OUR REF: 957A as-built redups

TITLE
DRIVEWAY PLAN & LONG-SECTION
1 ELANORA ROAD, ELANORA HEIGHTS

DRAWING NO
17817-1/C

TITLE
INTER-ALLOTMENT DRAINAGE PLAN
1 ELANORA ROAD, ELANORA HEIGHTS

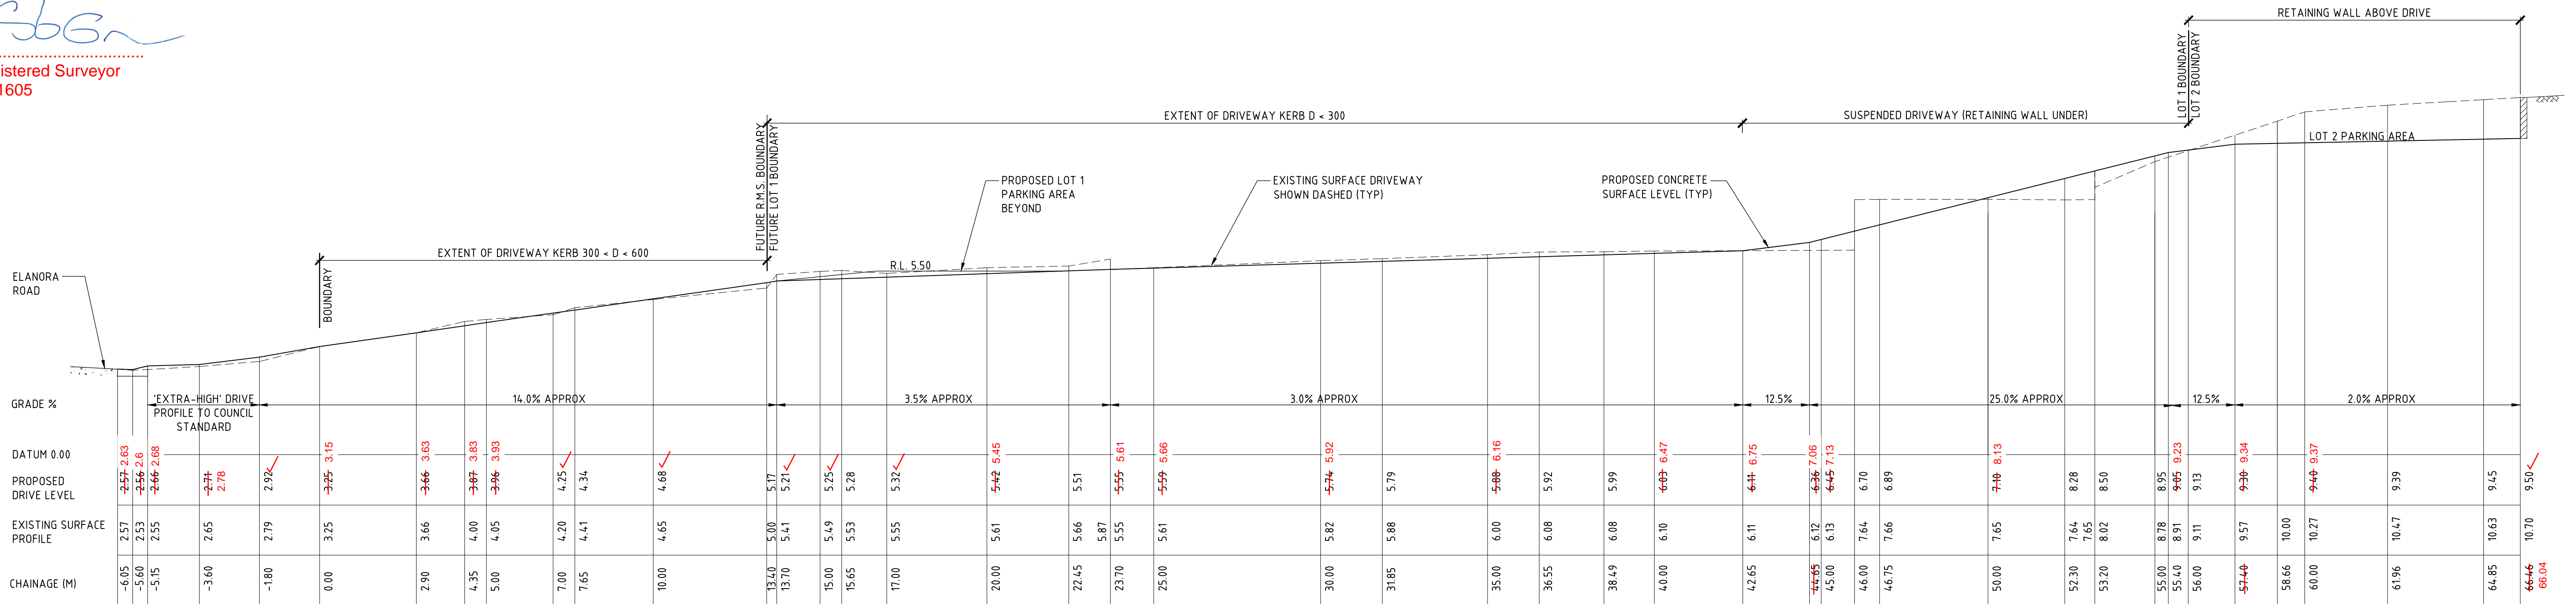
NOT INSTALLED VEHICLE IMPACT BARRIER WHERE D > 600

we have attended site on 5-10-17 and as built the newly constructed civil works.
we hereby confirm the dimensions, features and levels confirmed hereon in red represents finished works.

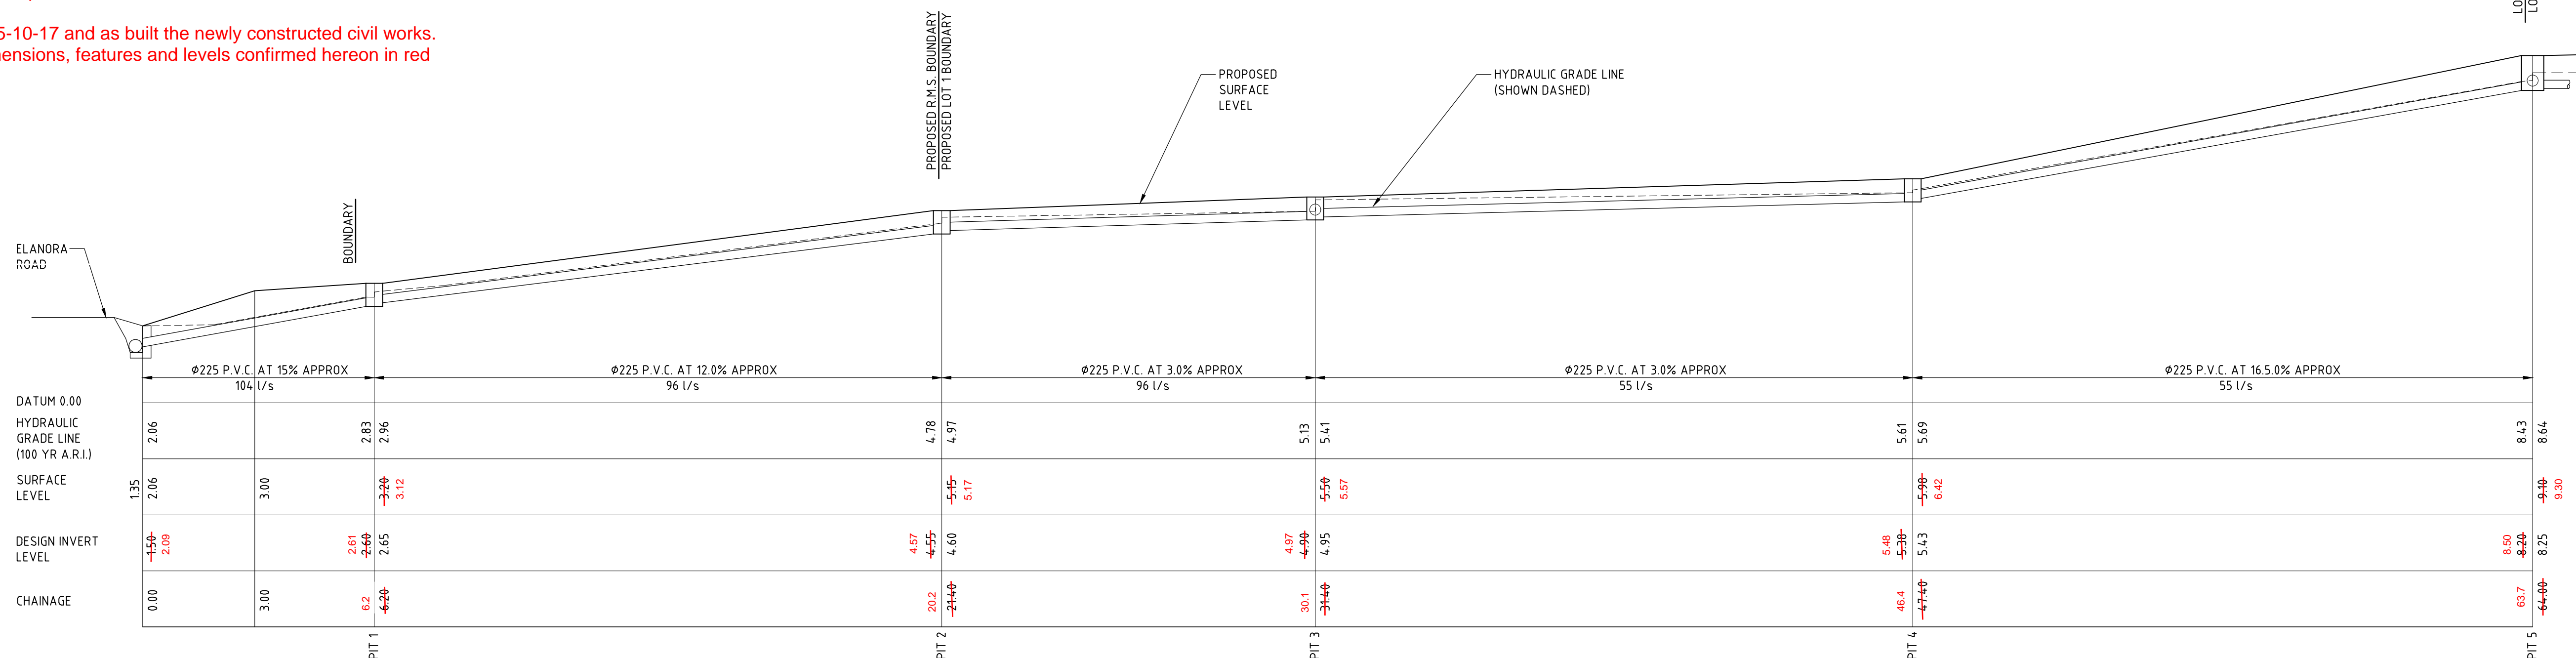
INLET PIT 7
450 SQ. INLET PIT
GRATE R.L. - 9.45
INVERT R.L. - ~~8.85~~ 8.80

we have attended site on 5-10-17 and as built the newly constructed civil works. we hereby confirm the dimensions, features and levels confirmed hereon in red represents finished works.
